WATER LICENCE INSPECTION FORM

Agnico Eagle Mines Limited (AEM)'s, Meadowbank Gold Mine was issued an amendment and renewal of water licence 2AM-MEA1525 on July 23rd, 2015 for a term of ten (10) years to expiry on July 22nd, 2025.

On October 21st a regularly scheduled compliance inspection was completed by Aboriginal Affairs and Northern Development Canada's Water Resource Officer (WRO), Christine Wilson with the assistance of AEM's, Environmental Coordinator, Jeff Pratt.

Description: July 24th, 2015 Water accumulation at the NPAG Waste Rock Extention also referred to as WEP

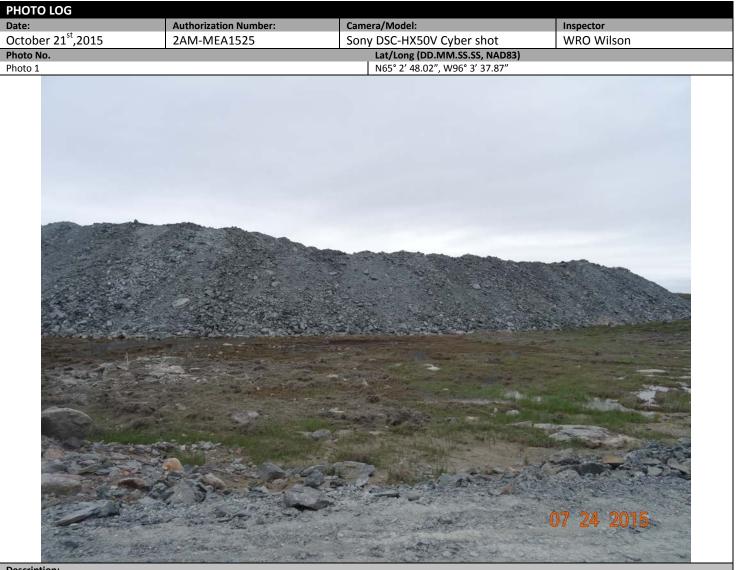
- 4. A small contact water collection pond (approximate location N65° 2′ 47.464″, W96° 3′ 40.342″) has been constructed at the North East side of the NPAG waste rock extension pile (WEP) of the Waste Rock Storage Facility (WRSF).

- a. The inspector request more information about the WEP collection pond including the construction, samples of the waste water, quantity of waste water recovered and respective hazards (see photo 1, 2 and 3).
